Product Quality Microbiology Data Sheet

ANDA: 202153

This memorandum is to re-assess the proposed proprietary name, Ruby-Fill, under NDA 202153, in response to a request from the Division of Medical Imaging Products (DMIP). DMEPA previously found the name acceptable in OSE Review# 2010-1489 and 2010-1495 dated December 16, 2010.

Figure 1. Administered radioactivity (mCi) versus time (calendar year); each data point is a literature study, vertical lines are ranges within the study, points in gray area not included in dotted trend line.

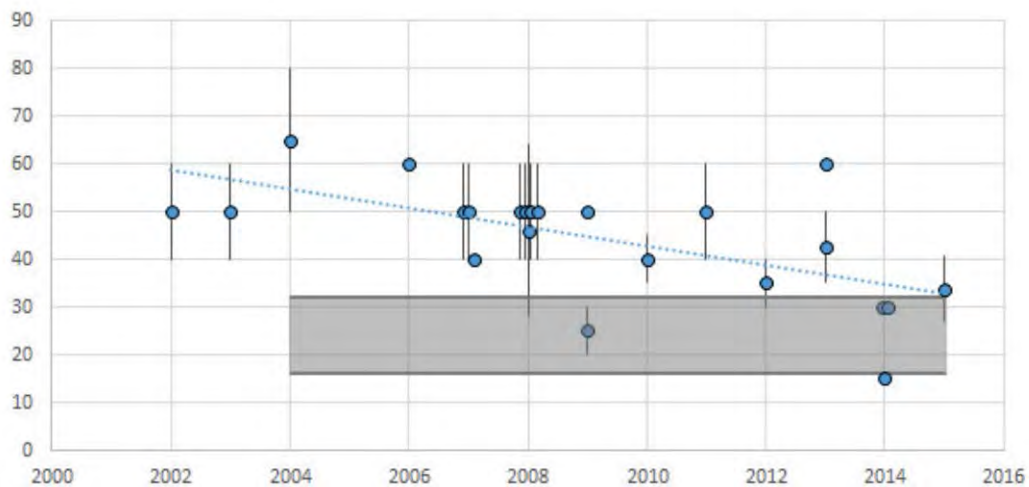
Reviewer's Comment

A formal meta-analysis for efficacy was not conducted by the applicant. The applicant's implicit reasoning is that the widespread use of lower dosing is evidence that lower doses provide adequate efficacy.
